Access Compliance Report

Public Rights-of-Way

Intersection ID: 10040250	Main Street: VAIL_AV	Cross Street: N/A	Location: N
ADA ID: 11401D81E6A2	Ramp Type: Directional1	Initial Pass/Fail: Fail	Overall Compliance: No
			Severity Score: 26.25

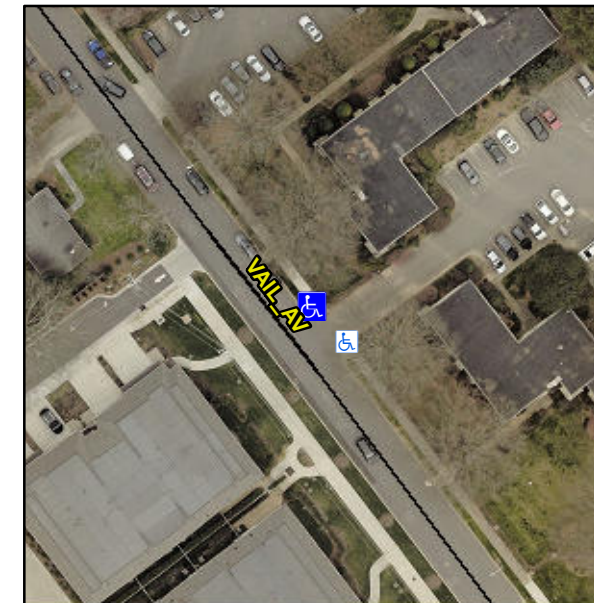
R304.2.2, R304.5.3

Compliance	Description	Data	Compliance	Description	Data
N/A	Ramp Length (in)	97.0	N/A	Grade Break?	N/A
Yes	Ramp Width (in)	67.0	N/A	Grade Break Slope (%)	0.0
No	Ramp Slope (%)	12.1	N/A	Grade Break XSlope (%)	0.0
No	Ramp XSlope (%)	4.3			
N/A	Flare Type LT	N/A	N/A	Flare Type RT	N/A
N/A	Flare Slope LT (%)	N/A	N/A	Flare Slope RT (%)	0.0
N/A	Flare Traversable LT?	N/A	N/A	Flare Traversable RT?	N/A
N/A	Landing Length (in)	0.0	N/A	DWS Provided?	N/A
N/A	Landing Width (in)	0.0	N/A	DWS Contrast?	N/A
N/A	Landing Slope (%)	0.0	N/A	DWS Length (in)	N/A
N/A	Landing X Slope (%)	0.0	N/A	DWS Full Width?	N/A
N/A	Landing Curb? (Y/N)	N/A	N/A	DWS Offset LT (in)	N/A
N/A	Shared Landing?	N/A	N/A	DWS Offset RT (in)	N/A
N/A	Gutter Ponding?	0.0	N/A	Gutter Slope (%)	N/A
N/A	Gutter Lip Ht (in)	0.0	N/A	Gutter X Slope (%)	N/A
N/A	Painted X Walk1?	No		Road Slope (%)	0.4
	X Walk 1 Direction	To SE		Road X Slope (%)	0.4
	X Walk 1 Width (in)	N/A		Clear Space?	N/A

X Walk 1 Slope (%)	0.4	N/A	Clear Space to XWalk (in)	N/A
	X Walk 1 X Slope (%)	0.4	N/A	Storm Grate/Utility Hazard?	N/A
N/A	Ramp inside XWalk1?	N/A		Storm Grate/Utility Type	
N/A	Any Obstructions?	N/A			N/A
	Obstruction Type		Yes	Surface Condition? (G/P)	Good
			N/A	Curb Slope (%)	17.6

Remove & Replace Entire Ramp.
